Service Bulletin

Bulletin No.: P11281

Subject: Sliding Door Does Not Stay Open While Vehicle is on a Downslope and/or Sliding Door Closes too Easily

Models: 2014 Chevrolet Express
2014 GMC Savana
Vehicles Built Prior to June 26, 2014

3955182

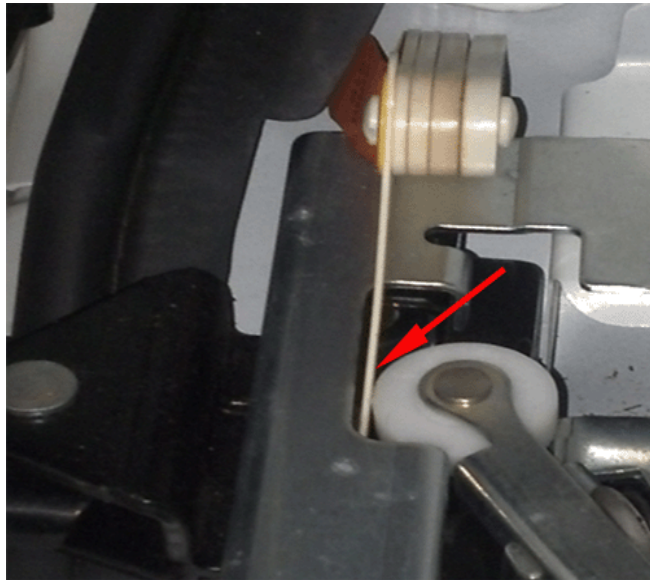
This condition may be due to the position of the roller arm not holding the sliding door in the open position.

Reposition the roller arm further outboard, to create a better hold on the sliding door while open, following the steps listed below:

- Use a pick tool and place under the base plate of the checker (1) and hook the tab (2) while bending inboard. Ensure the tab that is closest to the roller is now touching the trim edge (3) of the window with no gap as shown in the illustrations above.

- Measure the gap from the outboard edge of the roller to the track. Ensure a 1.25 mm (0.05 in) maximum gap.
